# ADDENDUM TO: VISTA-128BPT, VISTA-250BPT Series

(Use with Issue 800-06903)

**RE:** Important information about features that are new or changed in the Vista Turbo Series and its peripherals

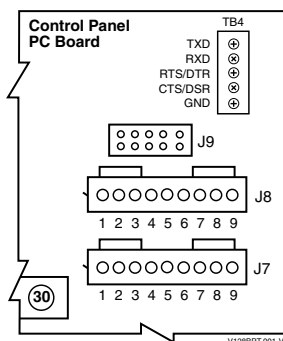
The J8 connector is no longer used for direct connect, serial printer or home automation applications. On all Vista Turbo Series panels, there are two methods of connecting to the serial (printer/automation) port:

**NOTE:** TB4 and J9 support WIN-PAK, however if you want to connect to a printer you must use TB4.

- 1) Using flying leads from terminal block TB4 to a 9- or 25-pin serial connector.
- 2) Plugging the VT-SERCBL cable into header J9. This connector terminates in a 9-pin serial connector. To connect this to a PC, you must use a standard straight through serial cable with a 9-pin connector on the panel end and the appropriate connector for your PC on the other end.
